**THE ARCADIA[®] REACTOR ANALYSIS
SYSTEM FOR PWRs METHODOLOGY
DESCRIPTION AND BENCHMARKING
RESULTS**

ANP-10297NP-A
Revision 0

SUBJECT: FINAL SAFETY EVALUATION FOR AREVA NP, INC. TOPICAL REPORT ANP-10297P, REVISION 0, "THE ARCADIA® REACTOR ANALYSIS SYSTEM FOR PWRs METHODOLOGY DESCRIPTION AND BENCHMARKING RESULTS" (TAC NO. ME3911)

Final Response to an RAI on ANP-10297P, "The ARCADIA[®] Reactor Analysis System for PWRs Methodology Description and Benchmarking Results Topical Report" (TAC No. ME3911)

Figure 1: Representative Axial Power Shape with Grid Depressions

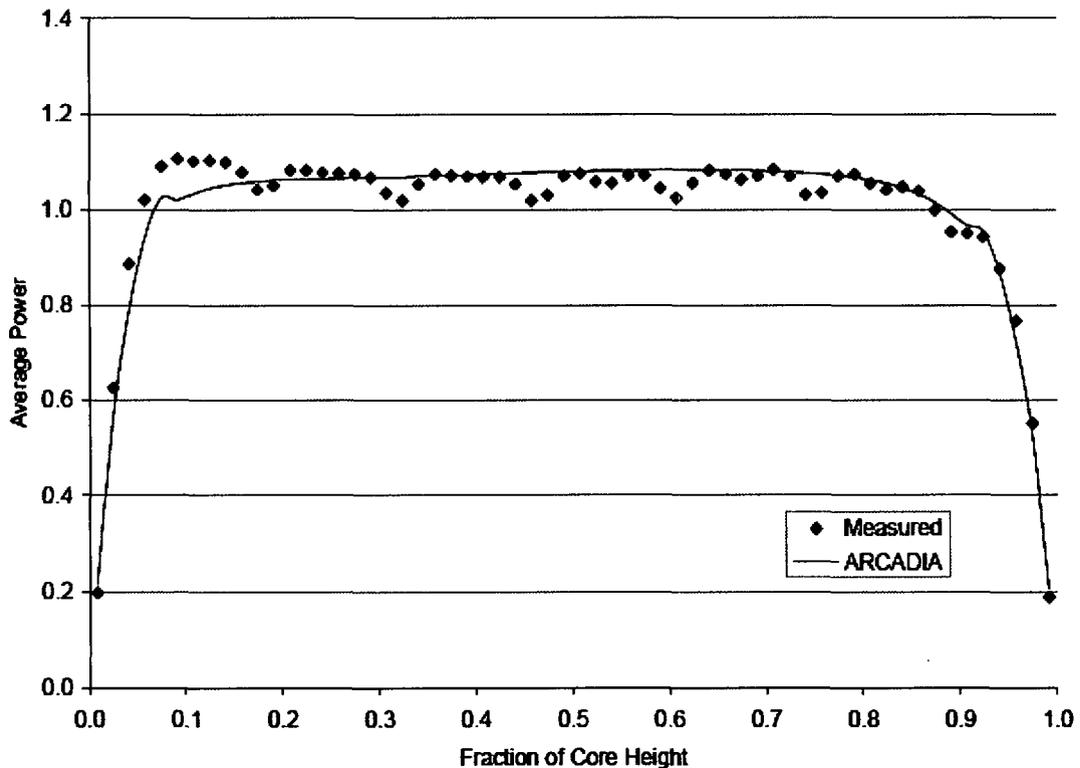
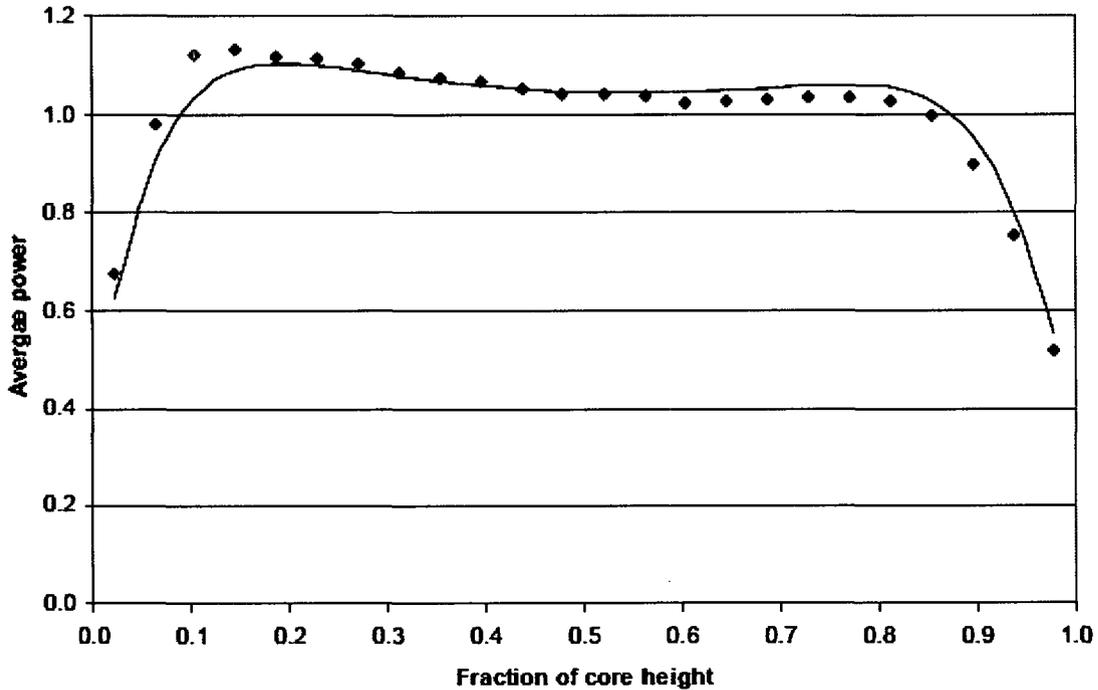
As expected the measured average axial power shapes have the similar axial power shape in all plants. A representative profile is shown in Figure 1. The grid spacer effects (grid depressions) seen on Figure 1, is common in axial power profiles of all plants except plant C and plant T. The plants C and T exhibit axial power shapes similar to the profile depicted in Figure 2. The smooth axial shape suggests that the power profile plots are not obtained from the actual detector readings but from reconstructed power shapes detector readings. However, the TR does not provide any information regarding the detector type or the power reconstruction method used in plant benchmarks. Consequently, AREVA was asked to provide further details for plant data and the interpolation/extrapolation method used to reconstruct the axial power shape if fixed core detectors were used in any plants.

AREVA provided (Reference 2) a table showing the detector type used in each plant in response to the RAI. As predicted, fixed incore Rhodium detectors are used in plants C and T. After detector power coefficients are calculated, detector inferred powers are linearly interpolated for each 24 axial node for comparison with the ARTEMIS™ predicted power. Based on the ARCADIA® benchmark results, this simple approach produces satisfactory results.

Figure 1: Percentage of Cycles with Labeled Spacer Grid Type in Uncertainty Data Base

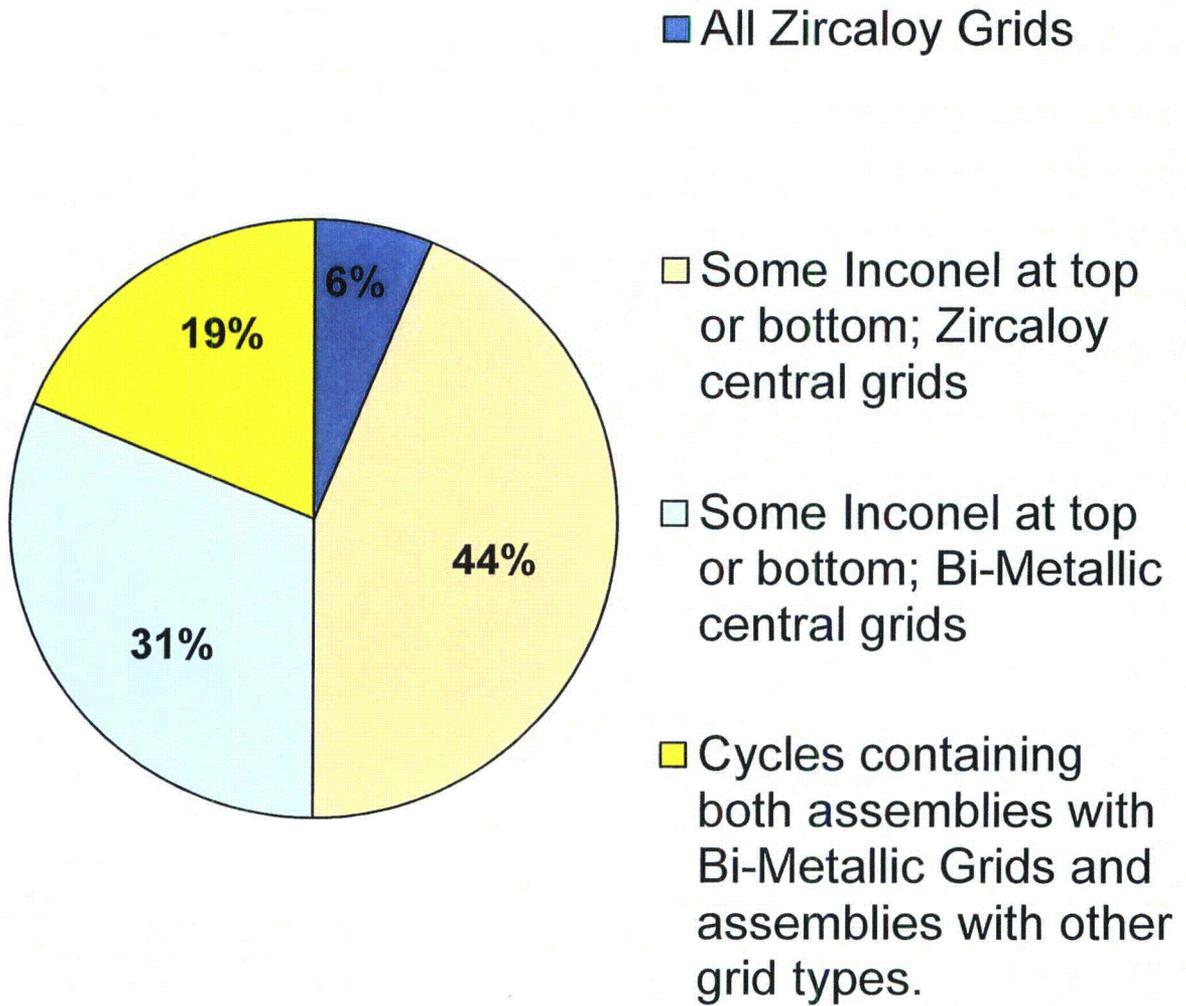
The statement on page 12-13 of the topical report is related to the NRC restriction and does not strictly define which locations of the Inconel grids affect the power depressions or the composition of an Inconel grid. AREVA NP proposes to revise this sentence upon issuance of the approved version of the report.

This statement will be revised to state:
